Access Compliance Report

Public Rights-of-Way

Intersection ID: 48204	Main Street: MUSKOGEE_DR	Cross Street: WALLACE_CABIN_DR	Location: NW
ADA ID: 592143922832	Ramp Type: BlendTrans1	Initial Pass/Fail: Fail	Overall Compliance: No
		Severity Score: 10

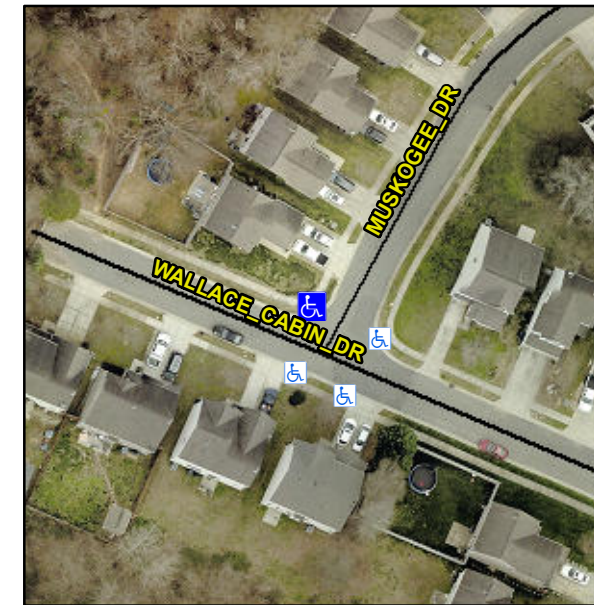
Not Found, R304.5.1, R304.5.3

Compliance	Description	Data	Compliance	Description	Data
N/A	Ramp Length (in)	48.0	Yes	BlendTrans Slope (%)	3.2
No	Ramp Width (in)	47.0	No	BlendTrans XSlope (%)	4.9
N/A	Flare Type LT	N/A	N/A	Flare Type RT	N/A
N/A	Flare Slope LT (%)	N/A	N/A	Flare Slope RT (%)	N/A
N/A	Flare Traversable LT?	N/A	N/A	Flare Traversable RT?	N/A
N/A	Landing Length (in)	N/A	N/A	DWS Provided?	N/A
N/A	Landing Width (in)	N/A	N/A	DWS Contrast?	N/A
N/A	Landing Slope (%)	N/A	N/A	DWS Length (in)	N/A
N/A	Landing X Slope (%)	N/A	N/A	DWS Full Width?	N/A
N/A	Landing Curb? (Y/N)	N/A	N/A	DWS Offset (in)	N/A
N/A	Shared Landing?	N/A			
N/A	Gutter Ponding?	N/A	N/A	Gutter Slope (%)	N/A
N/A	Gutter Lip Ht (in)	N/A	N/A	Gutter X Slope (%)	N/A
N/A	Painted X Walk1?	No	N/A	Painted X Walk2?	No
	X Walk 1 Direction	To S		X Walk 2 Direction	To E
	X Walk 1 Width (in)	N/A		X Walk 2 Width (in)	N/A
	X Walk 1 Slope (%)	9.0		X Walk 2 Slope (%)	4.1
	X Walk 1 X Slope (%)	1.0		X Walk 2 X Slope (%)	7.4

N/A	Ramp inside XWalk1?	N/A	N/A	Ramp inside XWalk2?	N/A
	Road Slope (%)	2.4		Clear Space?	N/A
	Road X Slope (%)	9.0	N/A	Clear Space to XWalk (in)	N/A
N/A	Any Obstructions?	N/A	N/A	Storm Grate/Utility Hazard?	N/A
	Obstruction Type			Storm Grate/Utility Type	
		N/A			N/A
			Yes	Surface Condition? (G/P)	Good
			No	Curb Slope (%)	15.1

Remove & Replace Curb Ramp With Two New Directional Ramps or Equivalent.
